Revise to Final
Drainage Report

~~PRELIMINARY DRAINAGE REPORT~~
FOR
**FALCON DISTRICT 49 TRANSPORTATION FACILITY, FALCON,
CO**

Owner: RTA Architects, 19 South Tejon St, Suite 300, Colorado Springs, CO. 80903.

May 23, 2022

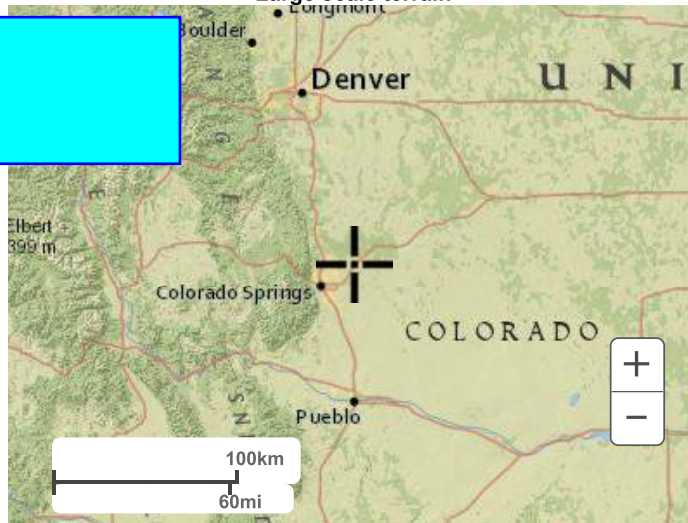
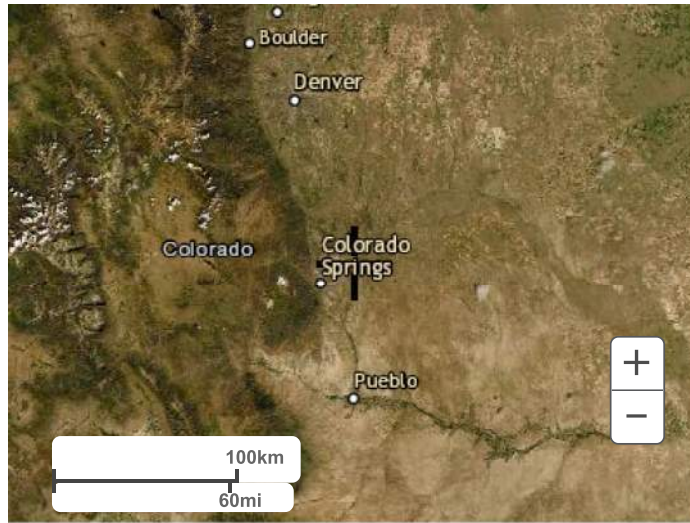
Delete

Delete

D49 TRANSPORTATION CENTER
SCHOOL DISTRICT NO 49
GENERAL LOCATION MAP

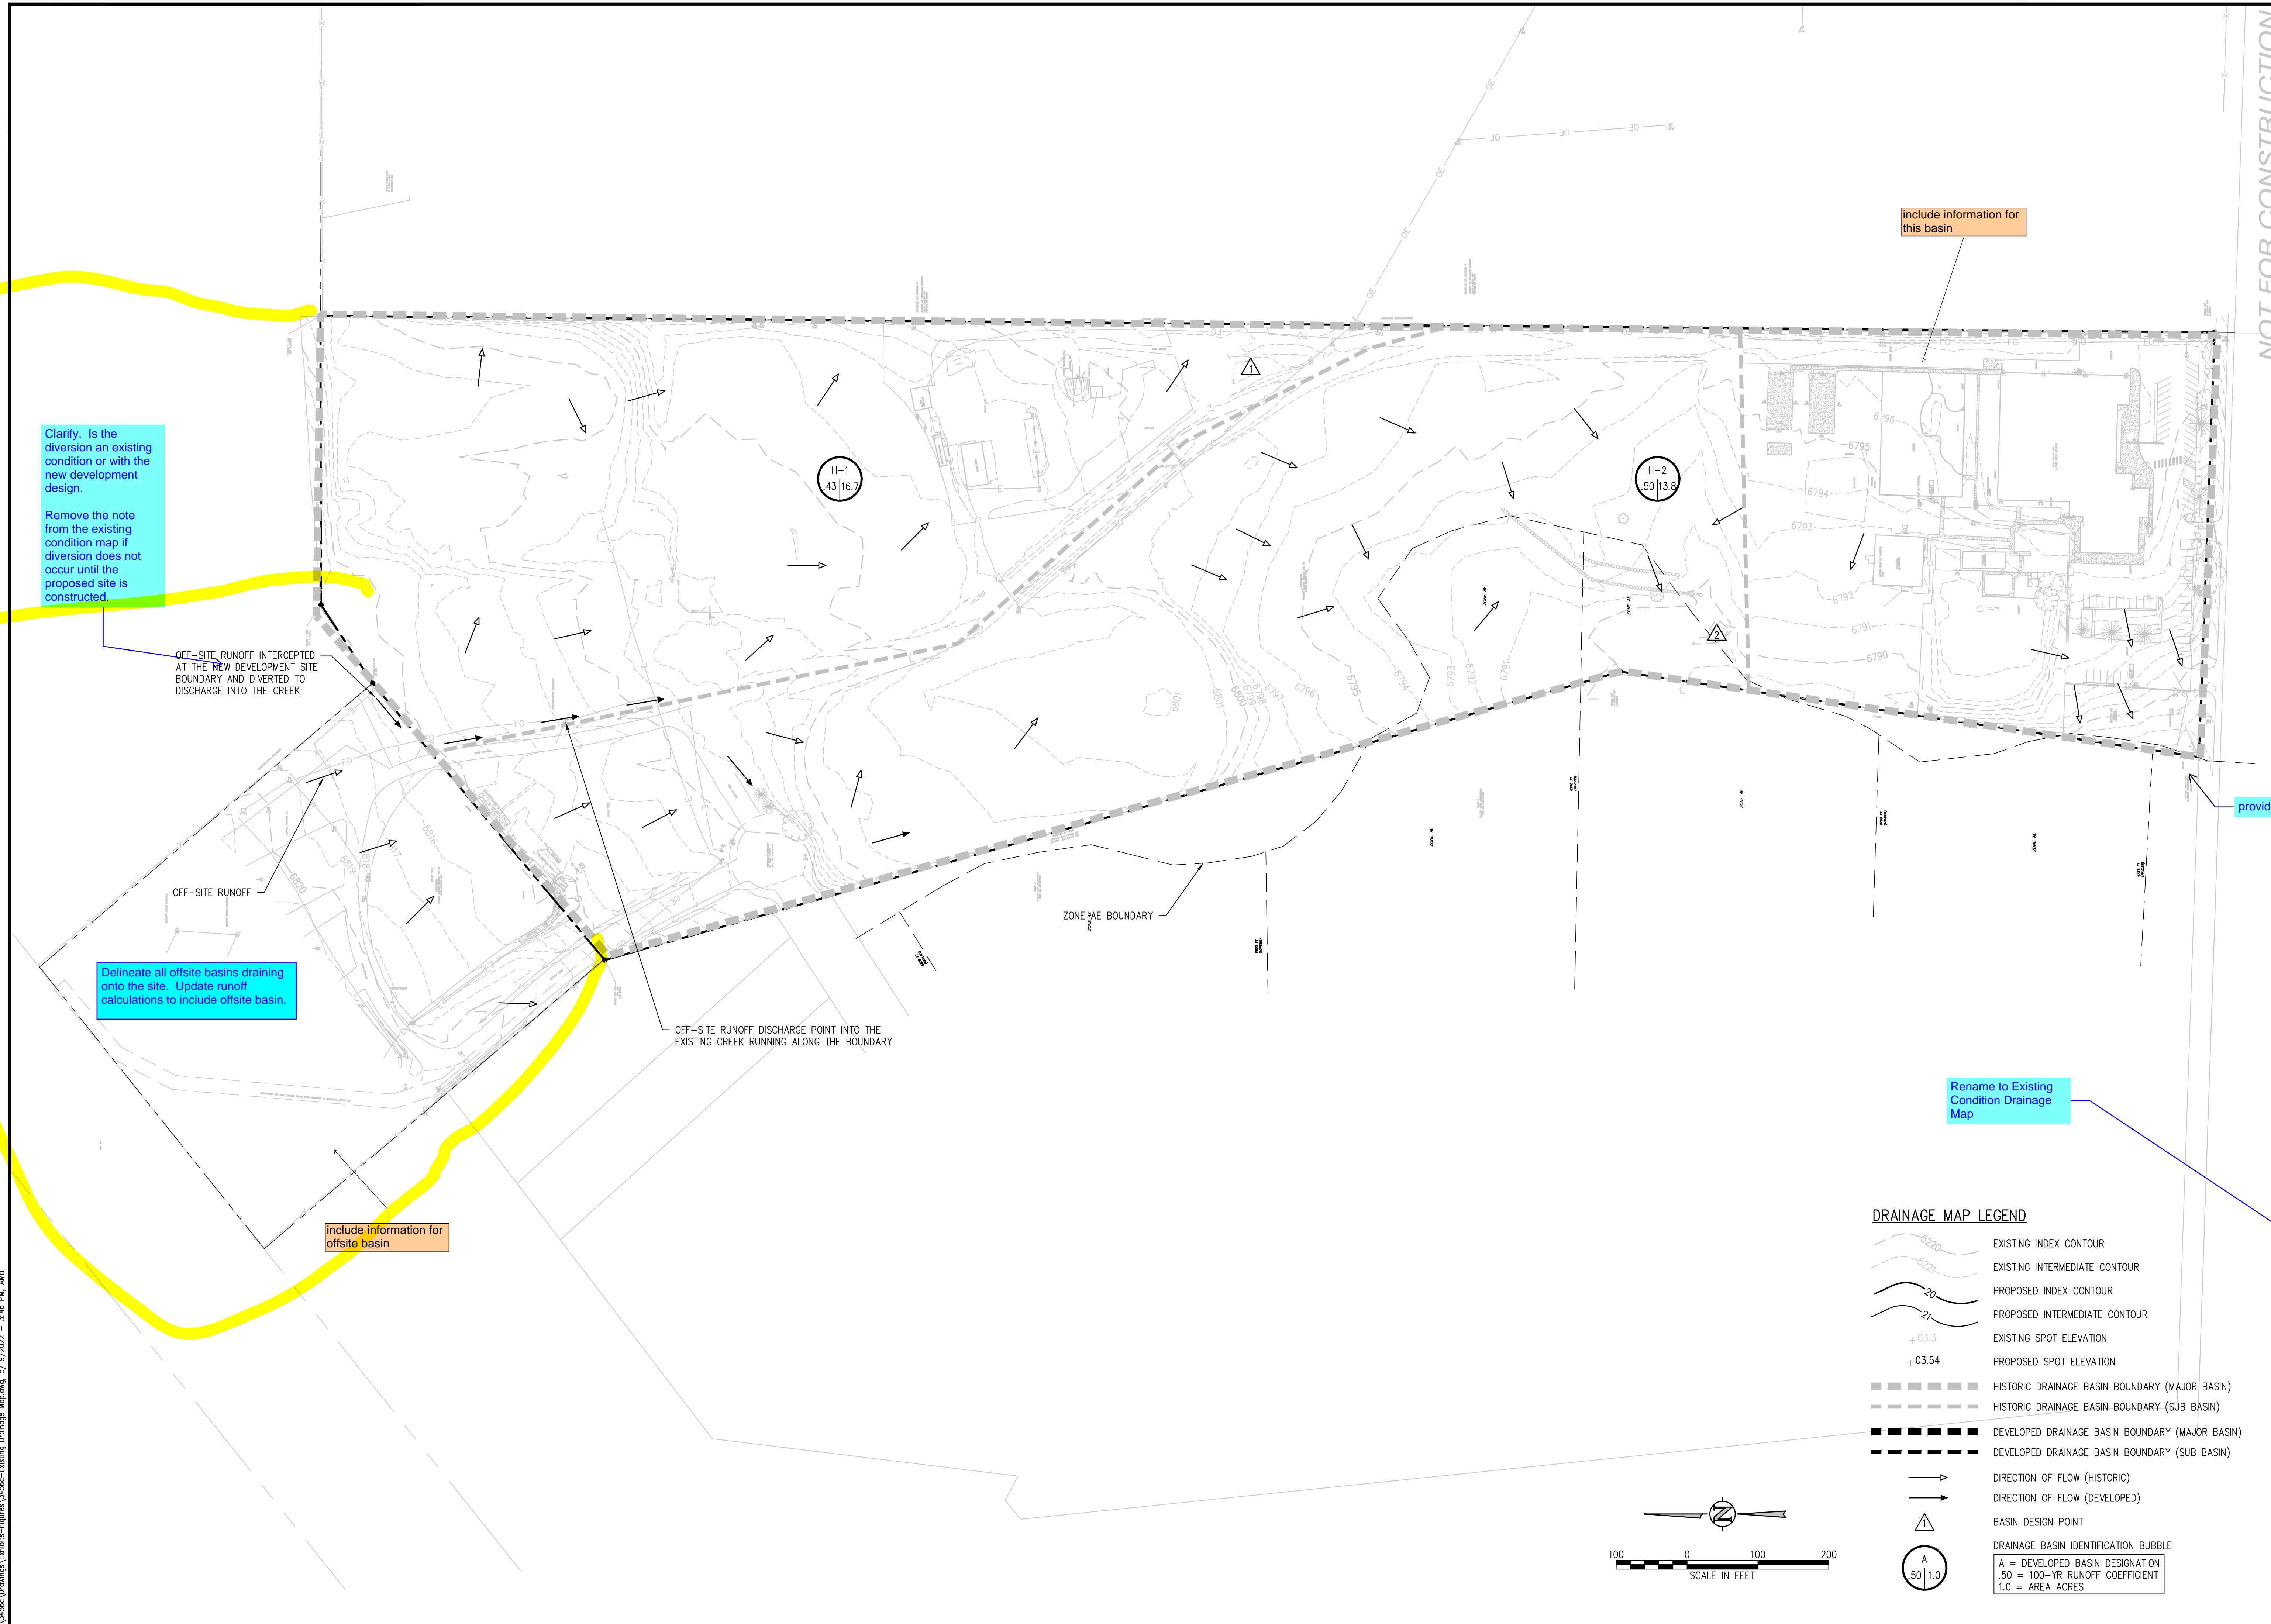
Clarify. Is the diversion an existing condition or with the new development design.
Remove the note from the existing condition map if diversion does not occur until the proposed site is constructed.

Delineate all offsite basins draining onto the site. Update runoff calculations to include offsite basin.

include information for offsite basin

provide design point

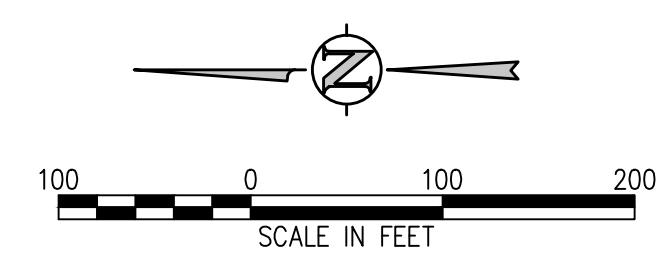
include information for this basin
